Subject: S.P. 2774-27504A  
Bridge No. 27504  
Revised Plan Sheets

Subject: S.P. 2774-16  
Bridge No. 27504  
Revised Plan Sheets

## Addendum 1 for changes to the Plans and Special Provisions for Bridge Nos. 7268 and 27504:

DES: RJR DR: RLS  
 CHK: GBB CHK: TRS  
 APPROVED: *5/29/13*  
 SHEET NO. 14R OF 34 SHEETS

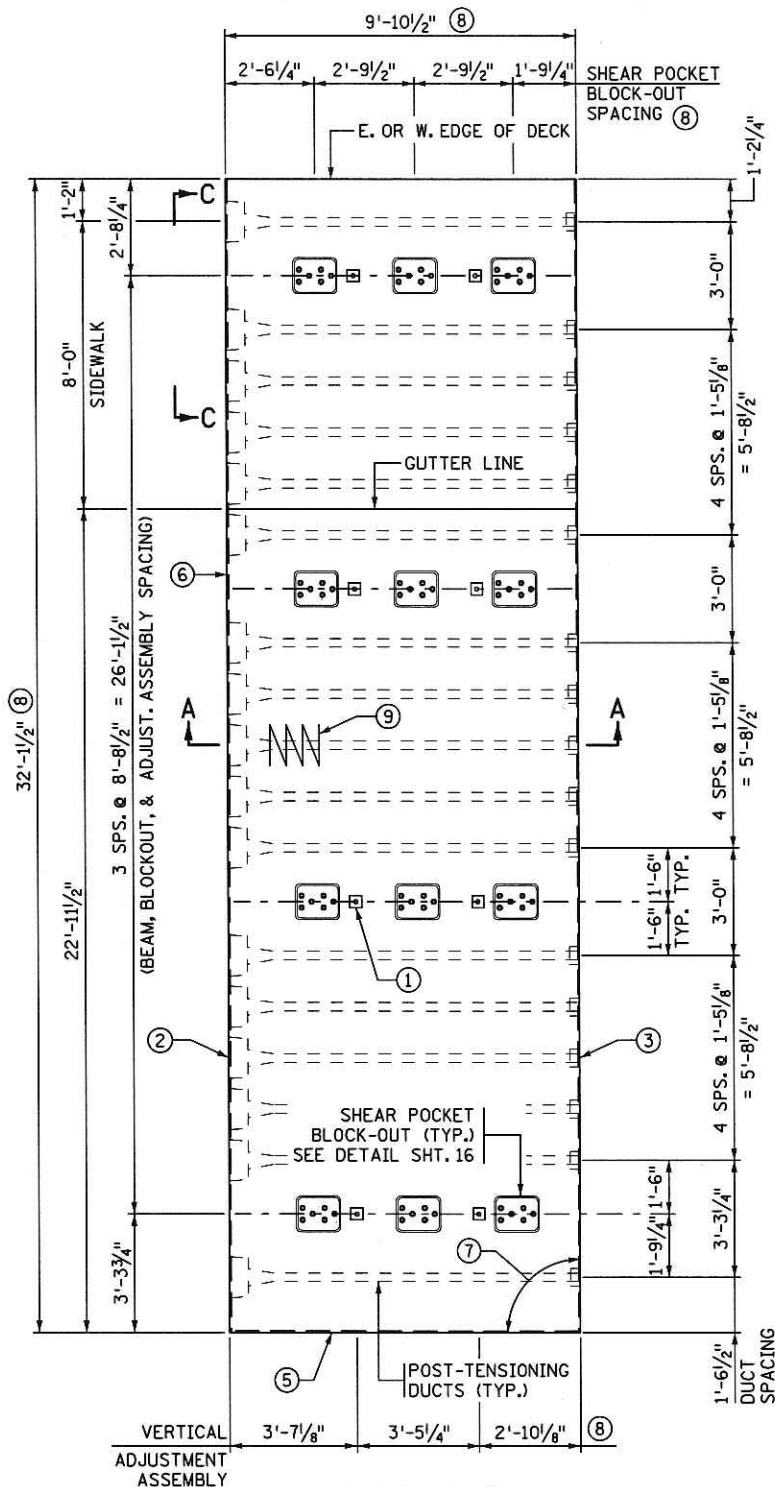
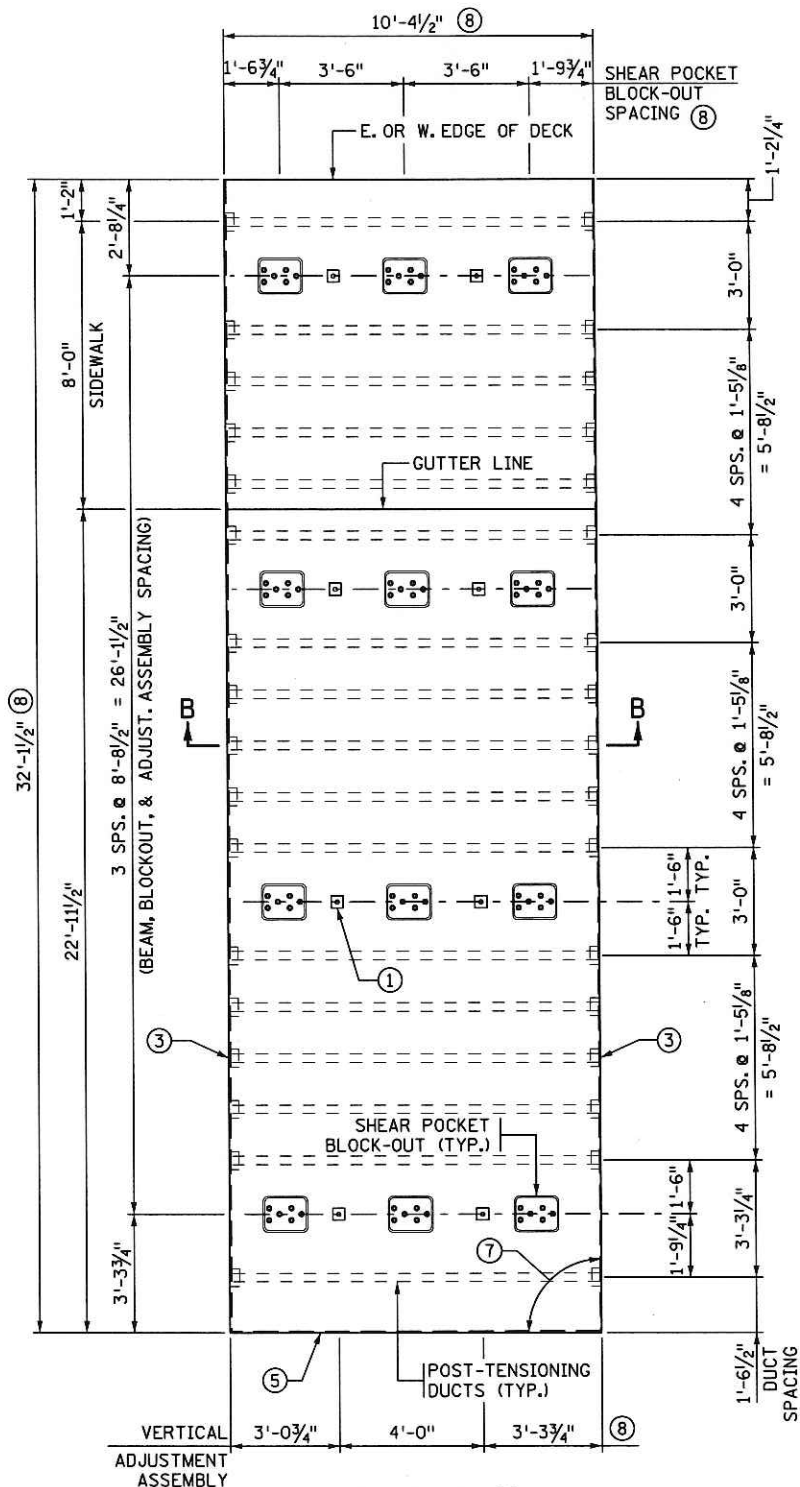
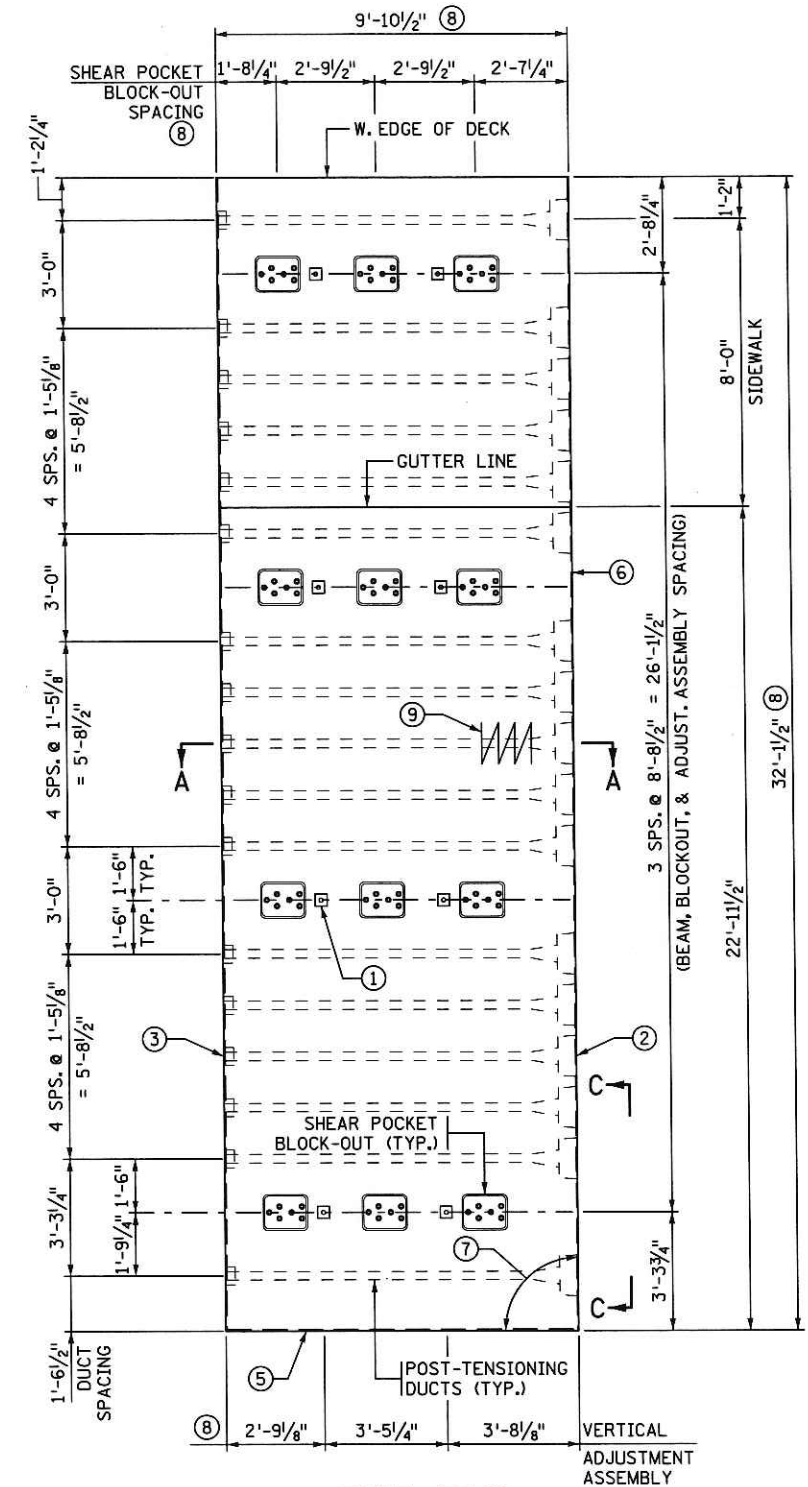
18) On Sheet 14R of 34 for Bridge No. 27504 the following changes were made:

- a. Added descriptions to Panel P1 and P3 titles.

CERTIFIED BY	<i>Benjamin J. Jilk</i> 9/12/13 LICENSED PROFESSIONAL ENGINEER	DATE	9-13-13	APPROVED BY	
NAME: BENJAMIN J. JILK	LIC. NO. 49852	TITLE:	SUPERSTRUCTURE DETAILS		
			DES: RJR	DR: RLS	BRIDGE NO. 27504
			CHK: GBB	CHK: TRS	
			SHEET NO. 16-R2 OF 34 SHEETS

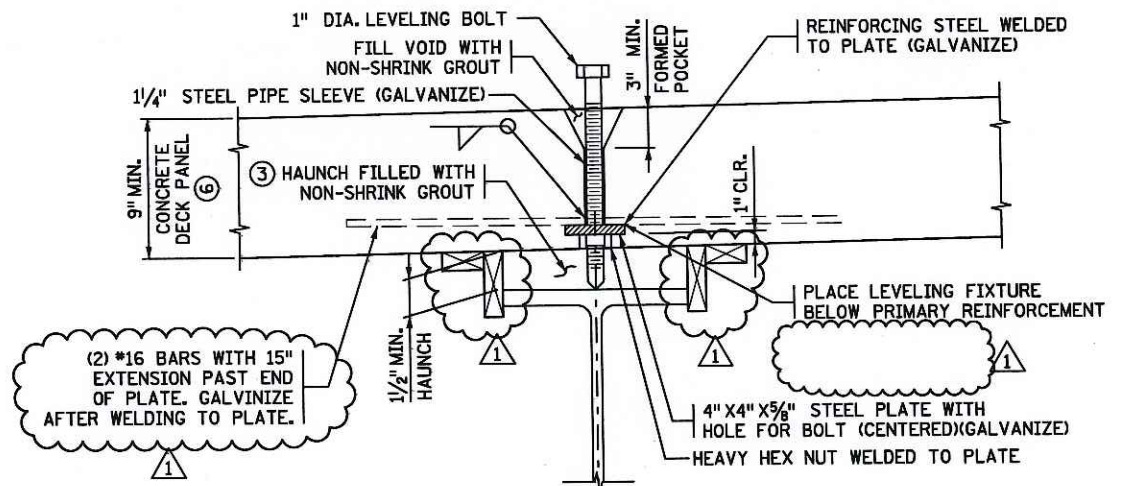
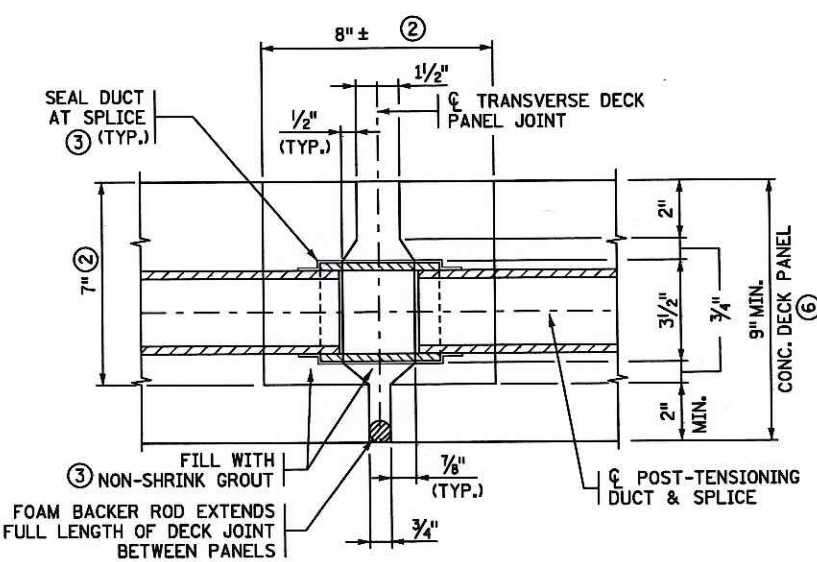
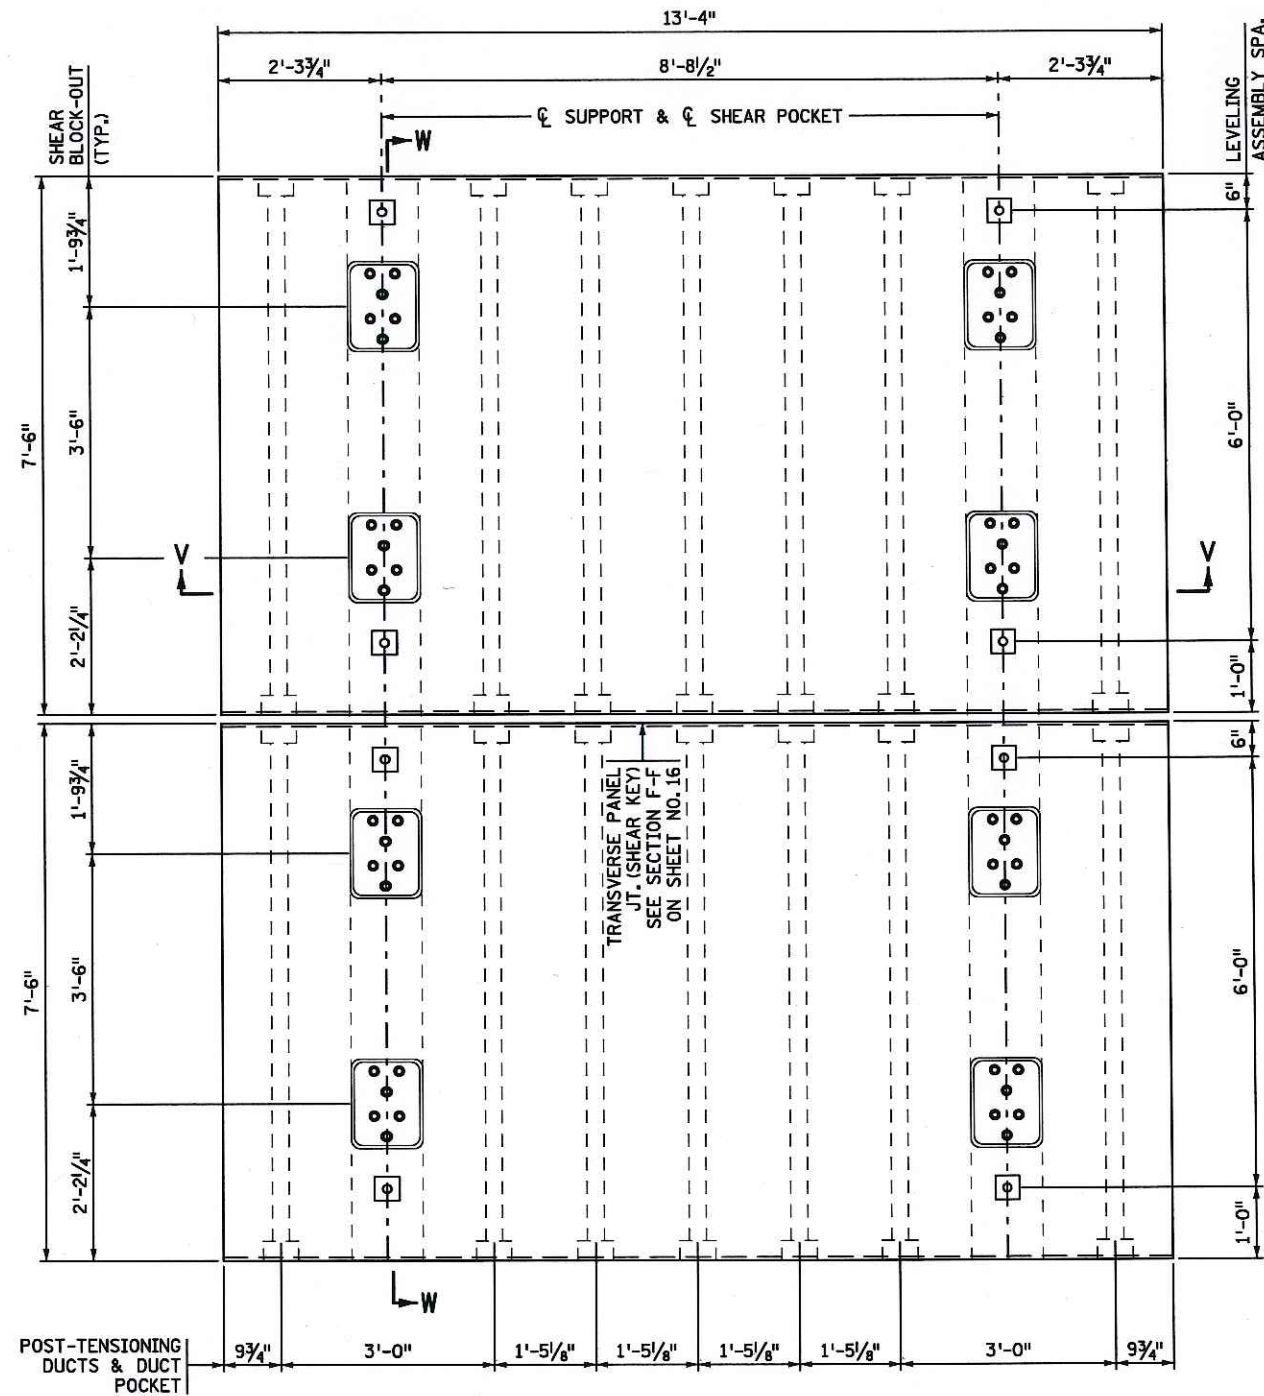
Enclosed are the revised plan sheets 16-R2, 17R and 18-R2 for Bridge 27504. These revisions were made to clarify section E-E on sheet 16-R2, to change slope of Mock-Up panel on sheet 17R and to change Construction Sequence on sheet 18-R2. These revisions will not affect the cost for this project.

19) On Sheet 16R of 34 for Bridge No. 27504 the following changes were made:

- a. Revised haunch forming scheme and call-outs.
- b. Revised note for reinforcing bars attached to vertical adjustment device.

DES: RJR DR: RLS APPROVED: *5/29/13*  
 CHK: GBB CHK: TRS  
**SHEET NO. 21R OF 34 SHEETS**

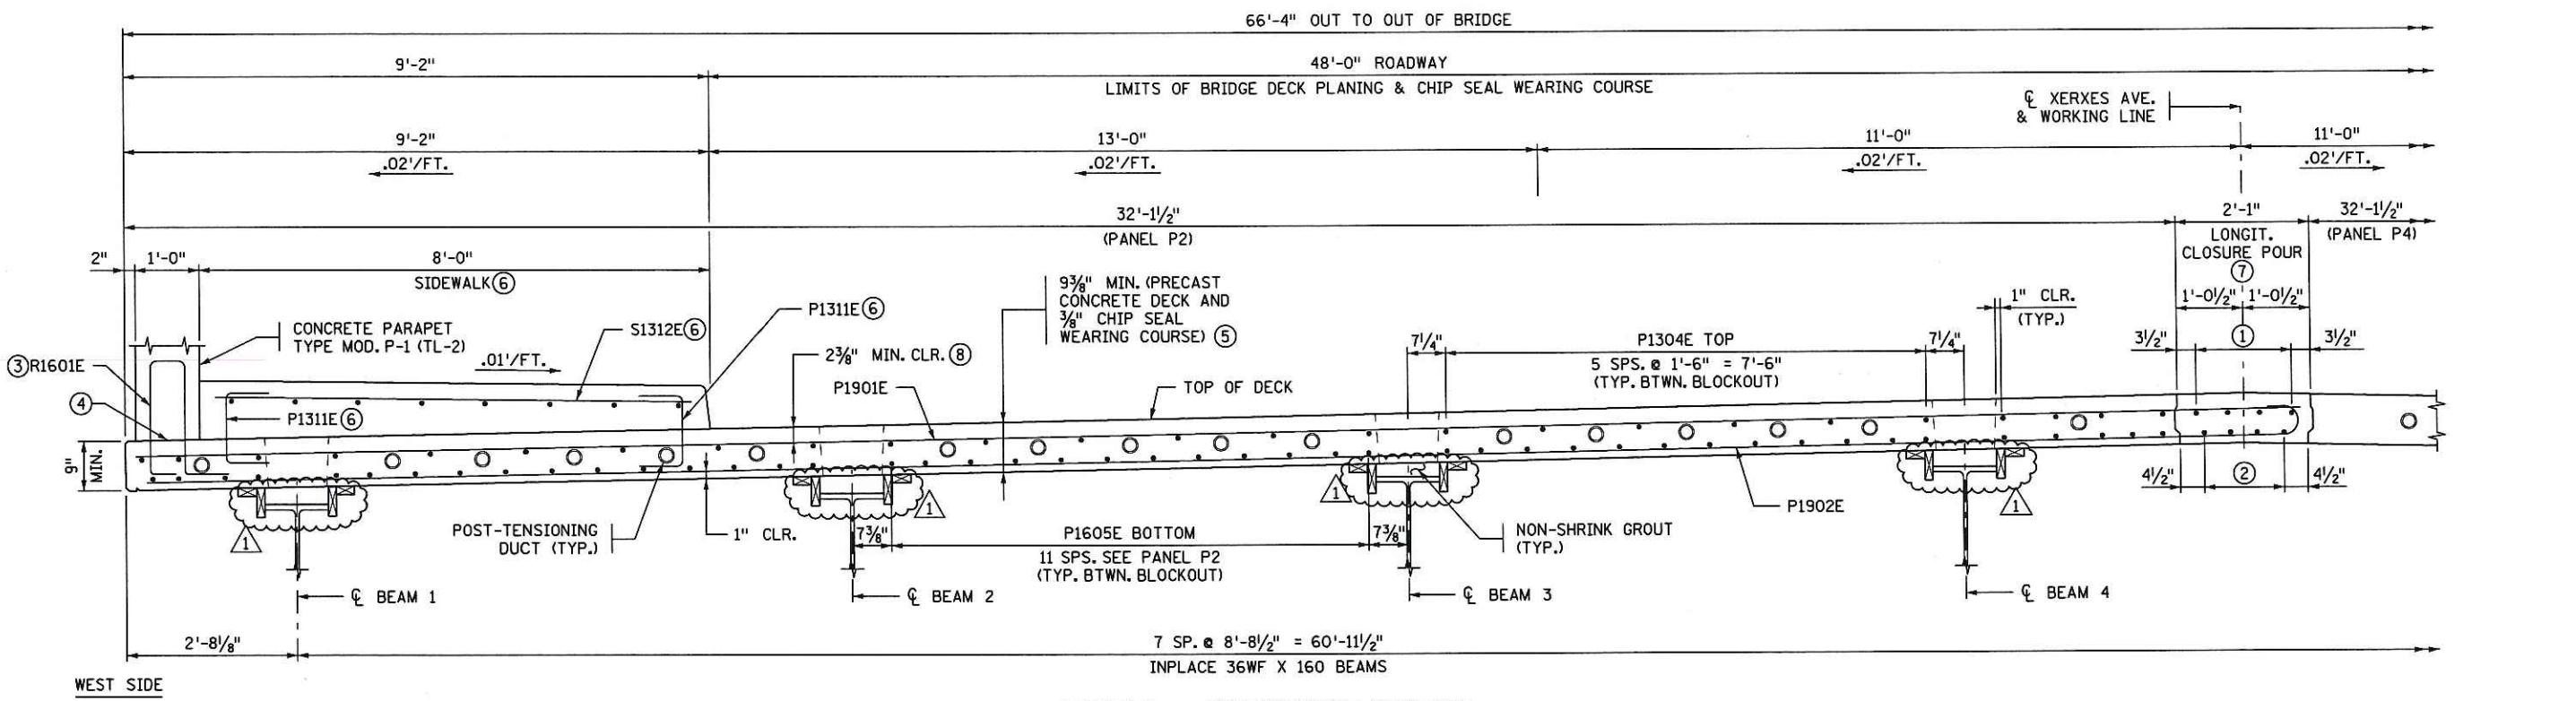
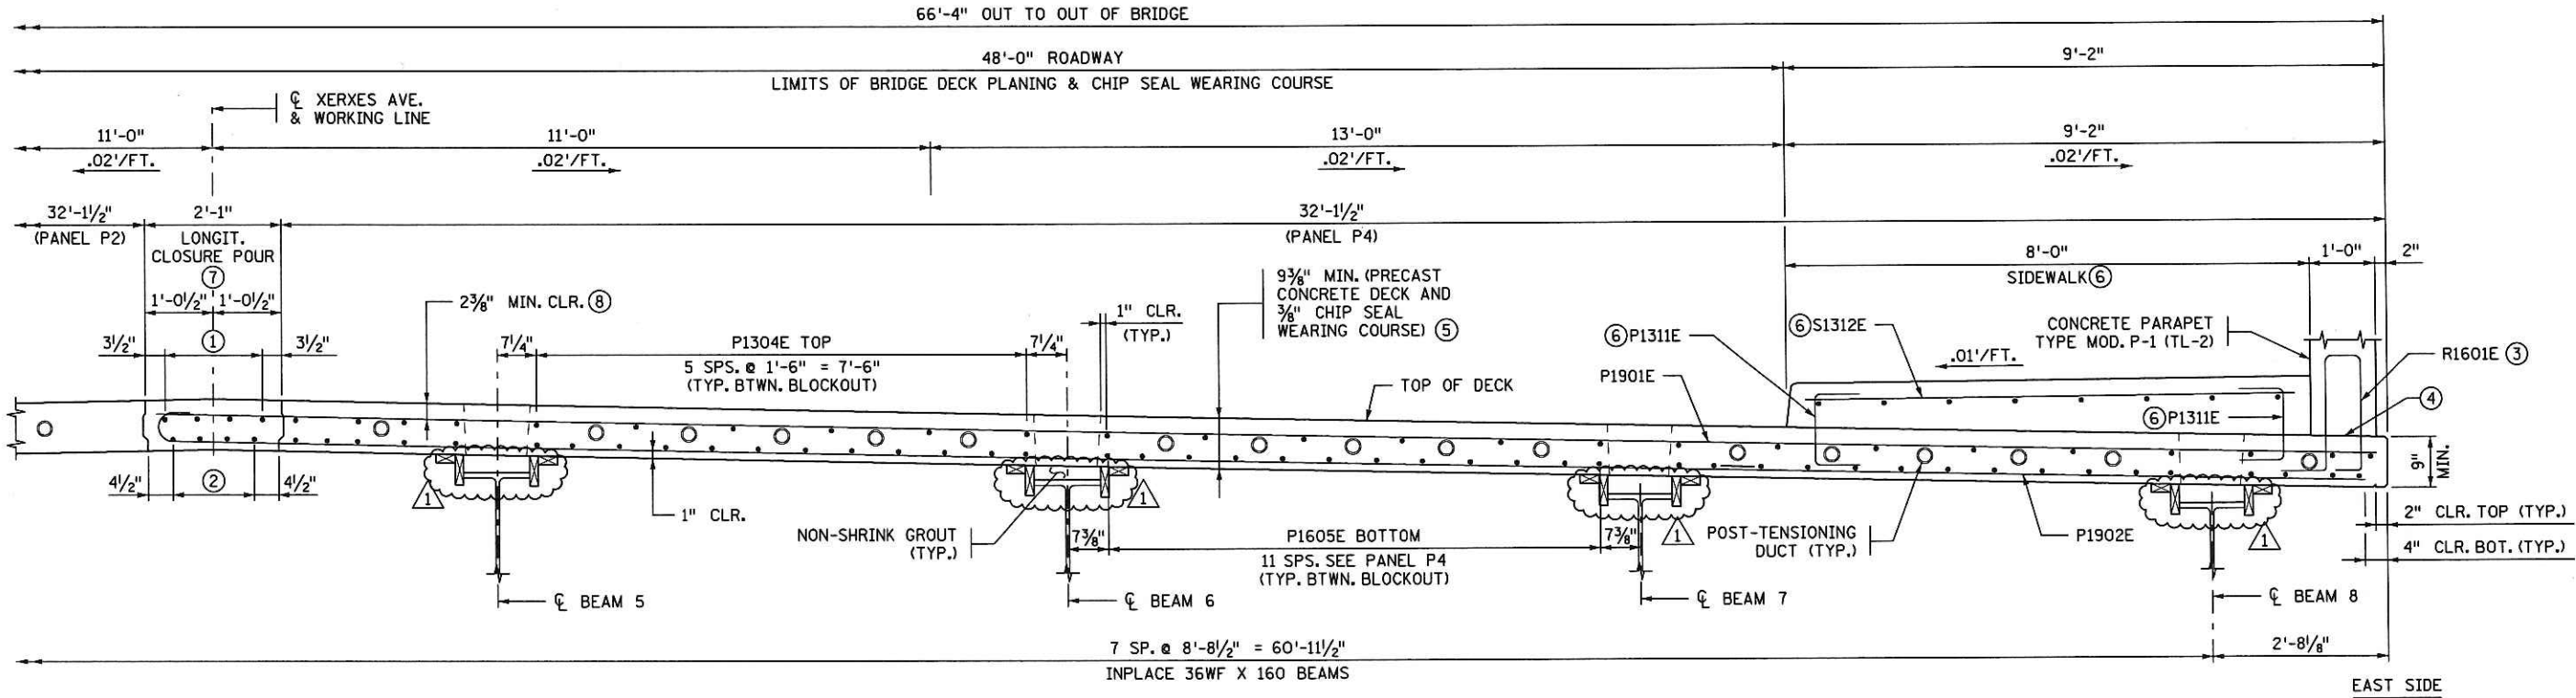
21) On Sheet 21R of 34 for Bridge No. 27504 the following changes were made:

- a. Revised haunch forming scheme.
